Moorebank Precinct East – Stage 2 WSUD Independent Audit

October, 2025
Project No. 255

Project title	Moorebank Precinct East – Condition of Consent 51 – Independent Audit	
Document title	Moorebank Precinct East Stage 2 – WSUD – 2025 Independent Audit Report	Project number 255
Description		
Client Contact	Mark Howley

Site Inspection Photos

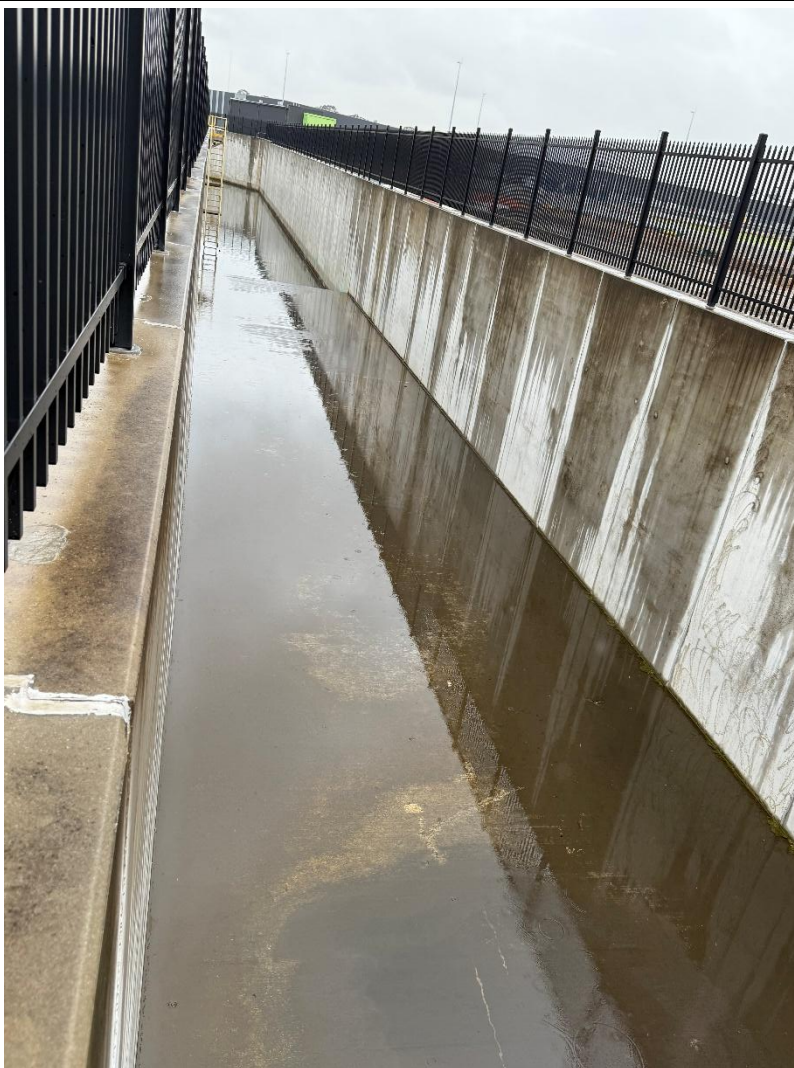
Photo	Description
	OSD 1 bioretention basin showing plant growth throughout the whole basin, denuded batters – batters recommended for planting pursuant to masterplan finalisation.
	Swale adjacent to the OSD 1 in good condition – Previous bank stabilisation works successful and under guard rail shade cloth placement is preventing litter blowing in.

Swale adjacent to the OSD 1 in good condition – (limited access associated with Moorebank Avenue realignment construction works).

Based on the latest masterplan, it appears that OSD 1 remains unchanged in the masterplan, Assuming this to be correct, it is recommended then that the batters of OSD 1 be vegetated in accordance with the original design drawings.

Sheet 12 lists appropriate species and densities for the batters. It is recommended that prior to planting that a quality topsoil, compliant with AS4419 be placed to a minimum depth of 150mm on the batters.
